PLAINTIFFS' AMENDED RULE 26 (a)(2) EXPERT WITNESS DISCLOSURE

September 15, 2004

Re: Holiday Inn
711 Dwight Street
Springfield, MA 01104

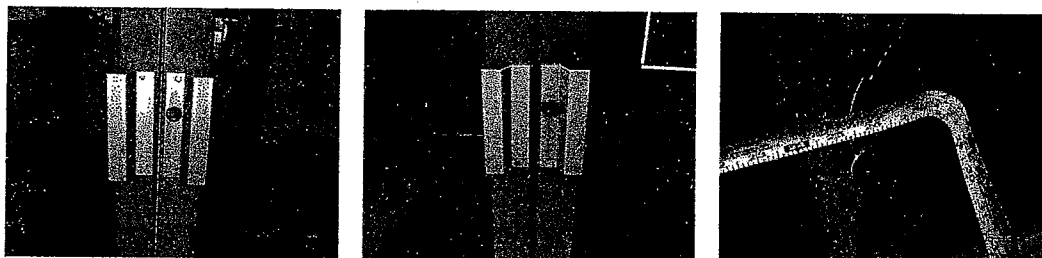
- A. There are 2 curb ramps located adjacent to the pool and the east side parking spaces. The slopes and cross slopes of these curb ramps are in excess of the requirements in sections 4.7.2 and 4.8.2 of the ADAAG. These curb ramps and the curb ramp located at the area of the passenger loading zone, near the front entrance, are chipped and lack a smooth transition from the street to the sidewalk violating sections 4.7.4 and 4.5.1 of the ADAAG.**
- B. The ramps lack detectable warnings violating section 4.7.7 of the ADAAG.**

- C. Both sets of doors at the east side entrance have hardware which is not easy to open with a closed fist violating section 4.13.9 of the ADAAG. Neither set of double-leaf doors provide the required 32 inches of clear width when opened violating sections 4.13.4 and 4.13.5 of the ADAAG.

1. Provide signage at the curb ramps located adjacent to the pool and the east side parking spaces stating that they are "Not Intended for Disabled Use" or repair them in accordance with sections 4.5, 4.7 and 4.8 of the ADAAG. The ramp located near the main entrance needs to be repaired in order to comply with sections 4.5, 4.7 and 4.8 of the ADAAG (this includes detectable warnings). This ramp must also connect to the accessible route with the "crosswalk" leading to the access aisles of the newly striped accessible parking spaces.

2. A solution to the problem of a lack of clear width and non-compliant door hardware at the sets of doors at the east side entrance is to replace them with automatic doors.

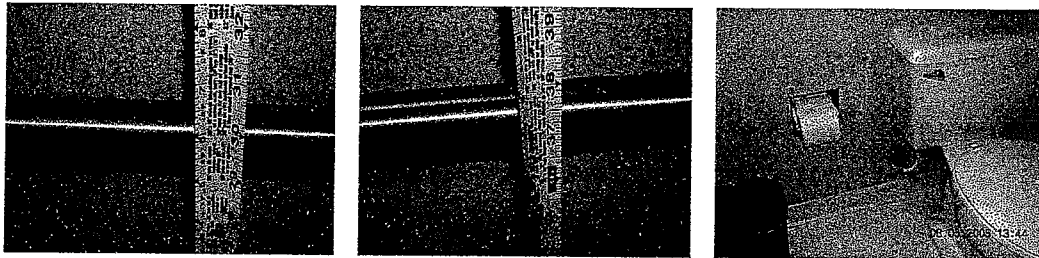
There is insufficient clear floor space in front of the bathtubs violating section 4.20.2 and figure 33 of the ADAAG. The length of the existing sink does not allow for sufficient clear floor space to make a transfer to the tub. An in-tub seat or a seat at the head end of the tub, mounted securely, is not provided violating section 4.20.3 of the ADAAG. Grab bars as required in section 4.20.4 and figure 34 of the ADAAG are not provided. Controls as shown in figure 34 are not provided.

Place the controls in the "offset" position as shown above in figure 34(b) of the ADAAG. Provide an ADA compliant tub seat (a securely fastened seat is required) and grab bars as shown in figures 33 and 34. Controls must be within reach from outside the tub and cannot interfere with the use of the grab bar on this wall. Tracks on the tub rim are not allowed as they can interfere with the transfer to tub seats. Dual grab bars on the back wall are needed for transfer to the seat and into the tub.

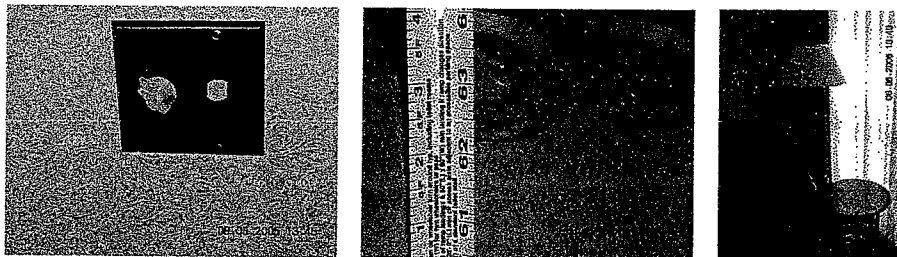
The grab bars at the water closets (toilets) do not comply with figure 29 violating section 4.16.4 of the ADAAG. There are dispensers which are not at the location required under 4.16.6 and figure 29(b) of the ADAAG.

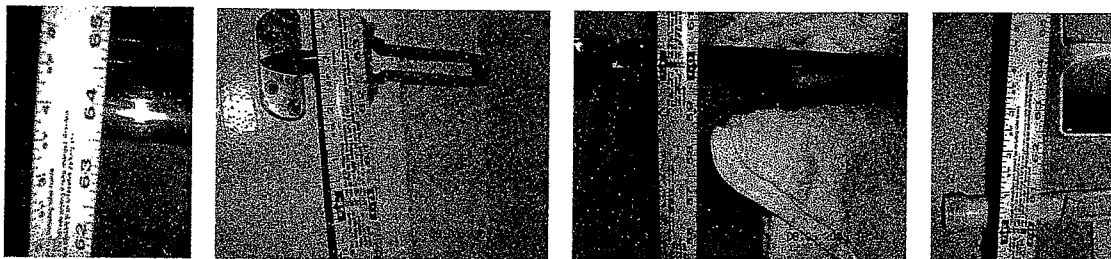
There are elements with controls which require tight pinching or twisting to operate violating sections 4.27.4 of the ADAAG.

Mechanisms which can be operated with a closed fist will generally satisfy these criteria. Controls which have slide or push-button mechanisms are preferable. All doors within designated accessible rooms and spaces should provide lever-operated or push-type mechanisms to facilitate opening/closing. If locks are provided they should not require tight grasping, pinching, or twisting of the wrist to operate. On
